MONTGOMERY COUNTY PLANNING DEPARTMENT
THE MARYLAND-NATIONAL CAPITAL PARK AND PLANNING COMMISSION

MCPB
Item # 1
9-22-08

FROM: David Paine, Coordinator (301) 495-2191 *DP*
Transportation Planning Division

SUBJECT: Seminary Road Intersection Improvement, Phase I Facility Planning Study
Project Prospectus Recommendations, Silver Spring Policy Area

Figure ES-1. Concept 4: Option C Revised Typical Sections

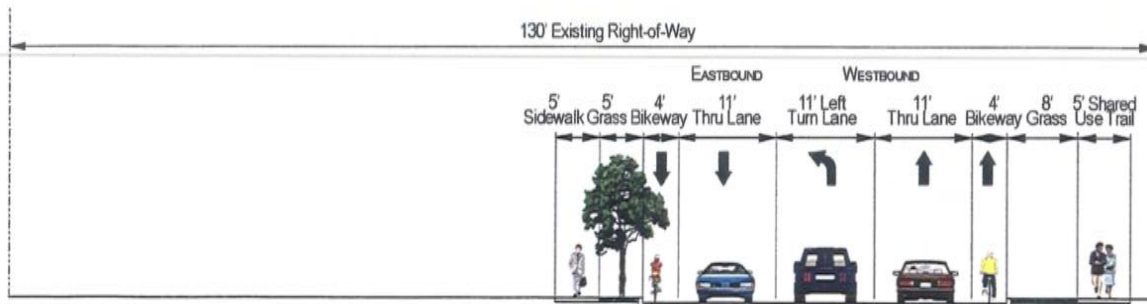
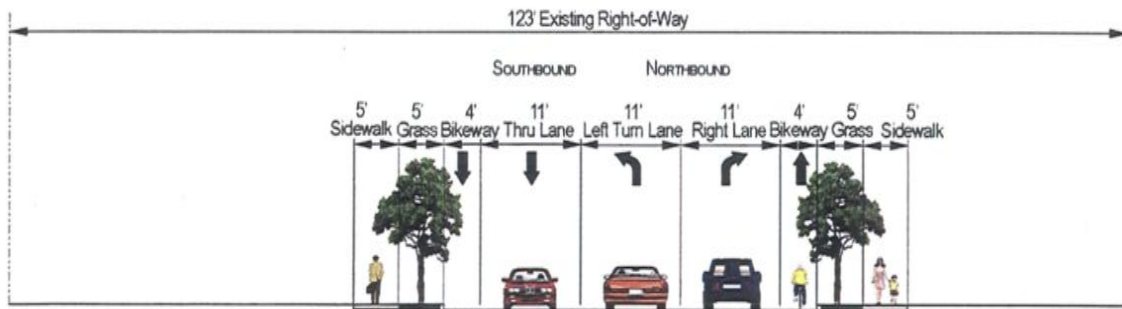
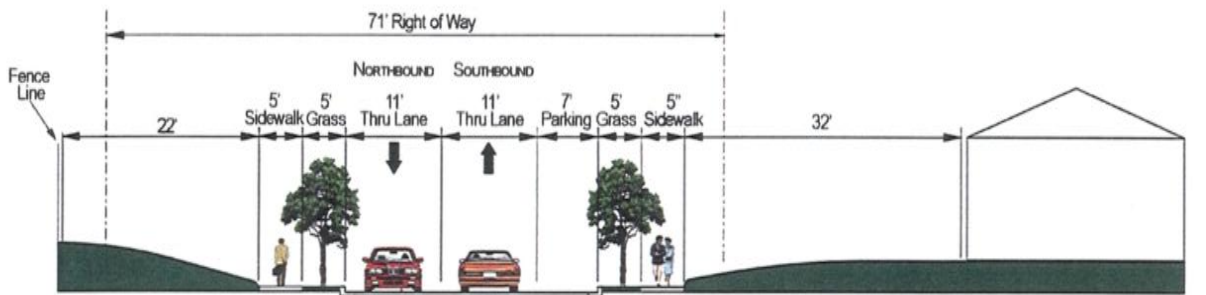
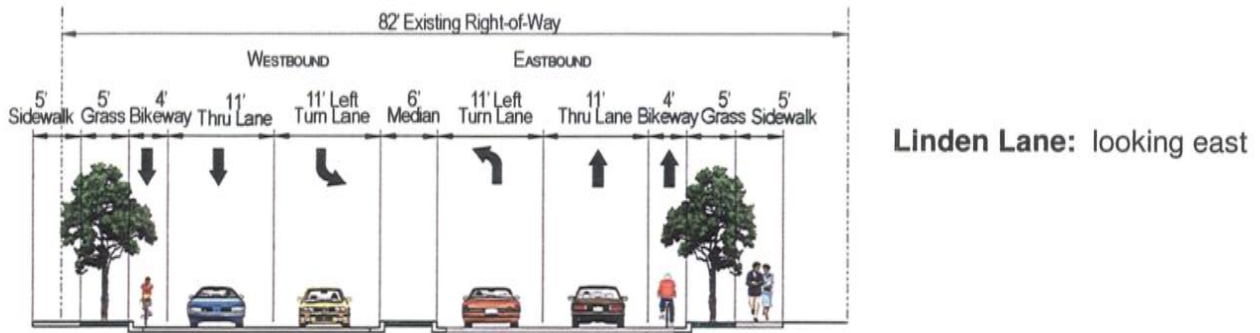
2. The new road code dimensions for a 4 lane arterial should be used for the section of Linden Lane between Brookville Road and Second Avenue.
3. The new road code dimensions for outside lane widths of 14' should be used throughout the project to accommodate bikes on-road, consistent with the master plan as signed, shared roadways.

This project proposes Linden Lane between Brookville Road and Second Avenue to have a cross section with 5' sidewalk and 5' landscape panel (10' curbside width), 4' bike lanes, two 11' thru lanes, two 11' turn lanes, and a 6' median. A median is proposed for pedestrian refuge. However, the proposed Road Code standard for a 4-lane Arterial roadway design is as follows: 2' offset, 5' sidewalk, 8' buffer width (a 15' curbside width), two 14' wide outside lanes, and 11' wide inside lanes, and no median.

The Master Plan does not call for a divided roadway at this location and the space for a median should not come at the expense of the curbside width. The new Road Code cross section would still accommodate cyclists on-road, but provide a better buffer for pedestrians, one that could be planted with street trees. The prospectus illustrates the cross section as having 5' wide buffer areas with trees, but this does not match current County practice of requiring a minimum 6' wide panel for planting street trees. The new standards should be adopted by the end of 2008. **We therefore recommend that the new road code dimension for a 4 lane arterial, be used for the section of Linden Lane between Brookville Road and Second Avenue.** Further, we support the planting of street trees throughout the project, as shown in the prospectus, and will look to the design in phase II to include sufficient space to do so.

Throughout the project, bike accommodations are shown as a demarcated 4' wide space labeled 'bikeway.' This occurs on Linden Lane between Brookville Road and Second Avenue, on Second Avenue between Seminary Place and Linden Lane, and on Seminary Road between Brookville Road and Second Avenue. 4' is not wide enough to be considered a full bike lane. On street accommodation can be adequately provided in this area through a shared roadway due to the design nature proposed: low design speeds and fully controlled intersections, if additional space is provided to allow trucks and buses enough space to pass a cyclist. Second Avenue is listed as a signed, shared roadway in the Countywide Bikeways Functional Master Plan. **The new road code dimensions for Arterials, with outside lane widths of 14', should be used throughout the project to accommodate bike on street, consistent with the master plan as signed, shared roadways.**

Concept Plan 4: Option C - Revised

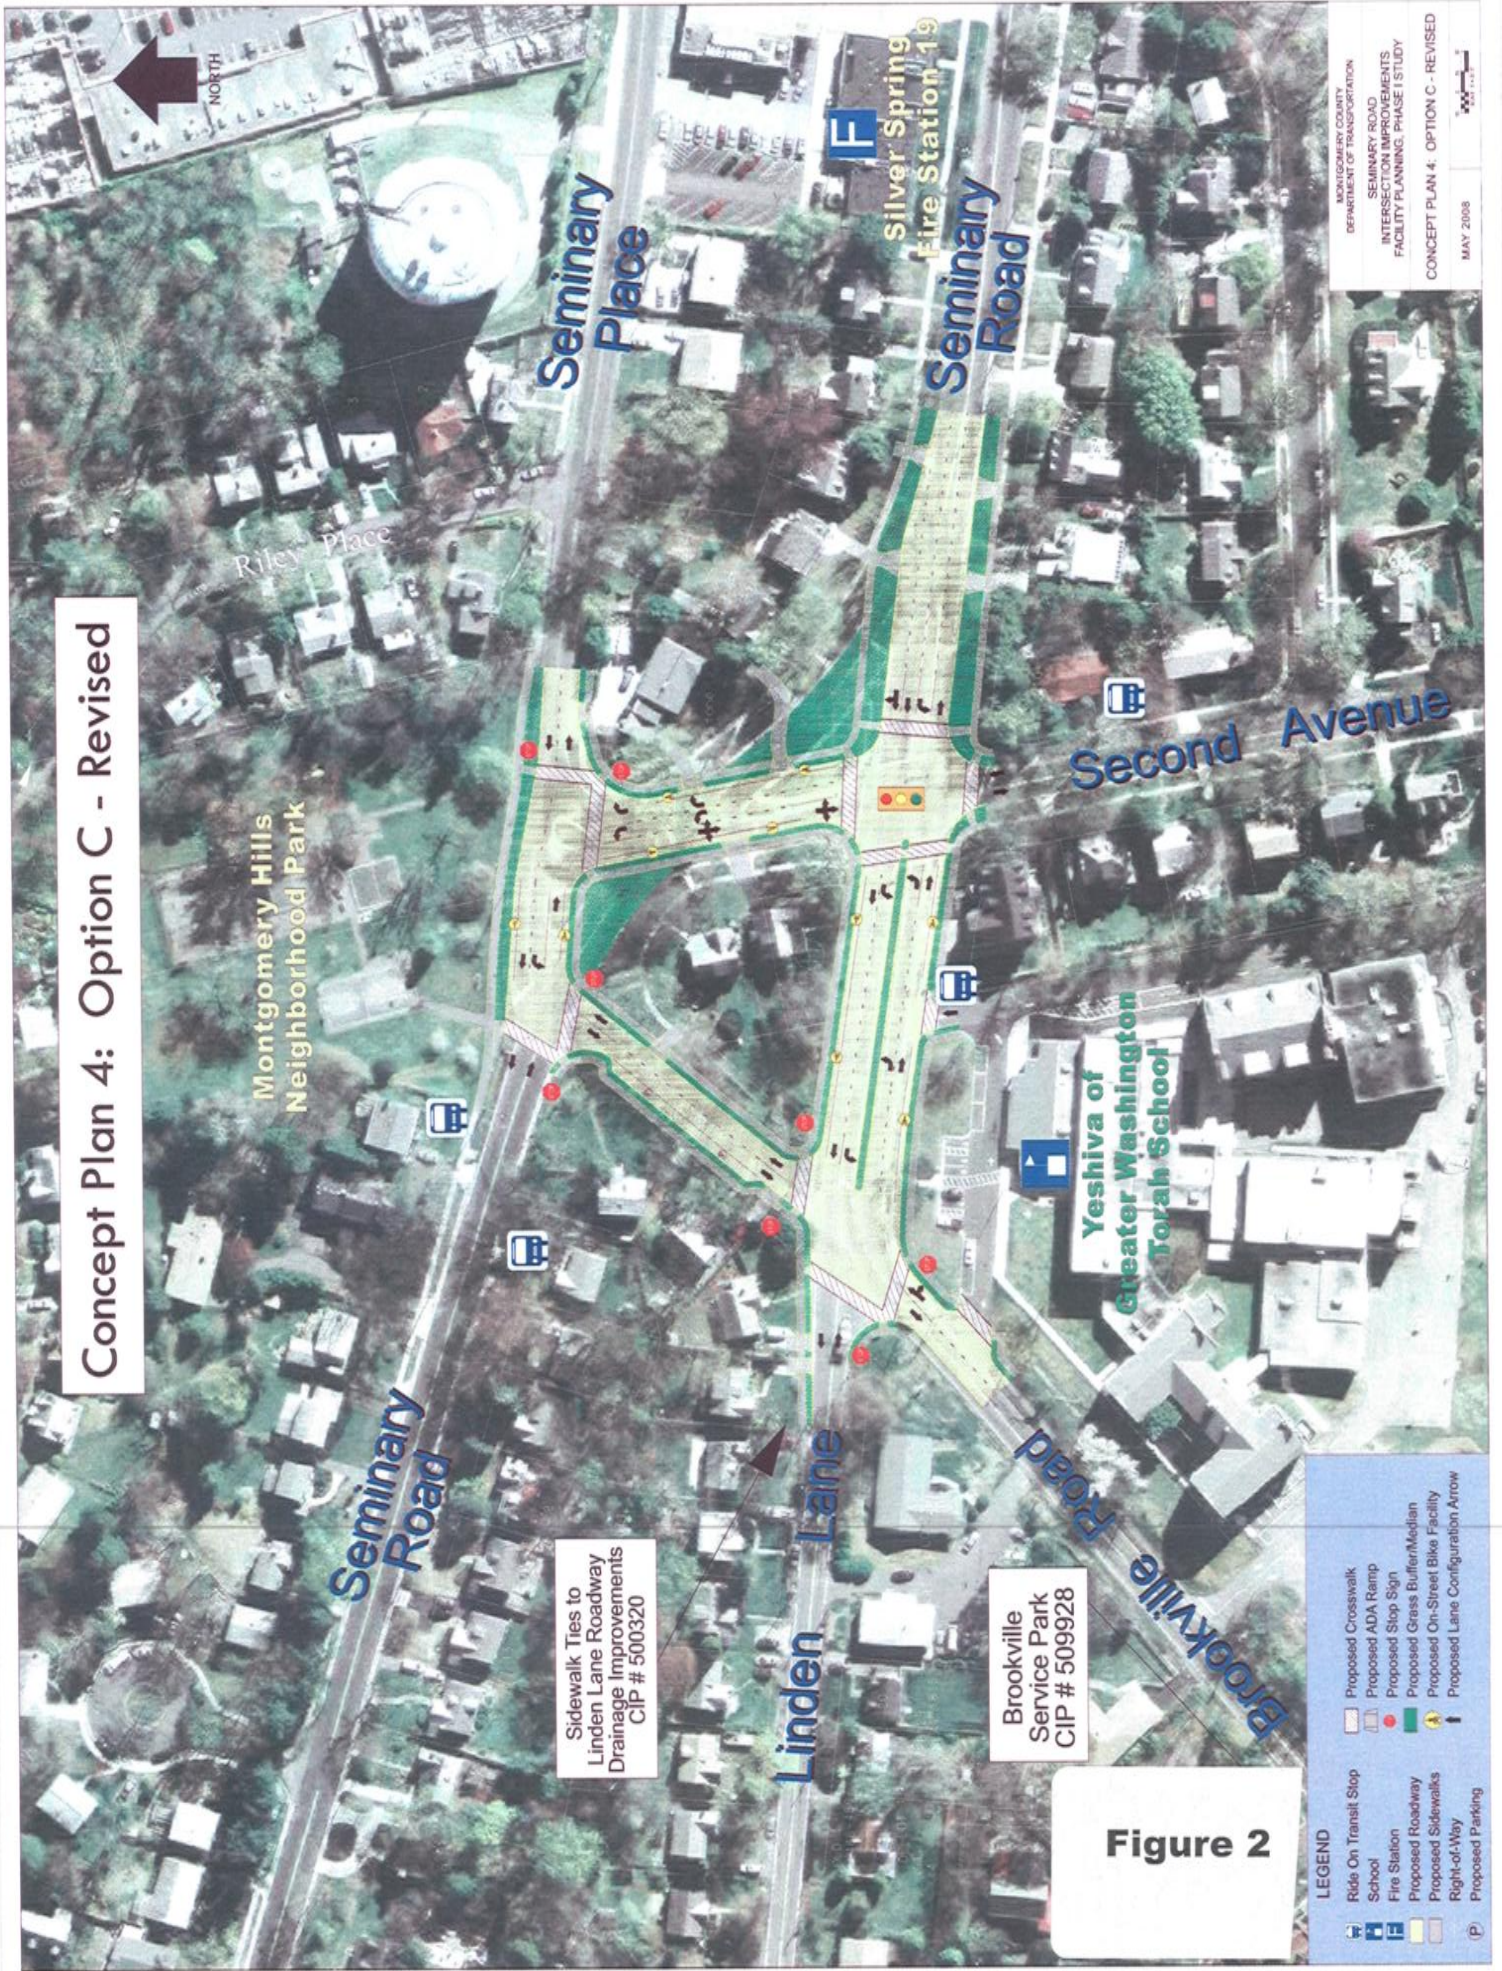
1. The Seminary Road Intersection Improvement Facility Planning Study should proceed to Phase II of the Facility Planning process to develop a detailed design for the completion of the Recommended Alternative, with the modifications listed below.

- The westbound lane of Seminary Place as it transitions to Seminary Road should maintain a straight bearing, rather than present three angle points to drivers continuing west through the intersections.
- Second Avenue needs to be lined up so that the northbound lanes on the south side of the intersection point at northbound lanes on the north side of the intersection, rather than southbound lanes as shown.
- The curb radius on the southeast quadrant of the intersection of Second Avenue and Seminary Place appears to be too wide and should be reduced.
- Brookeville Road at the north end needs to be made more perpendicular at its intersection with Seminary Road.
- Further investigation into the issue of road names and addresses should be done for Seminary Road or Second Avenue to determine whether the realigned segment of roadway should be called Seminary Road or Second Avenue.
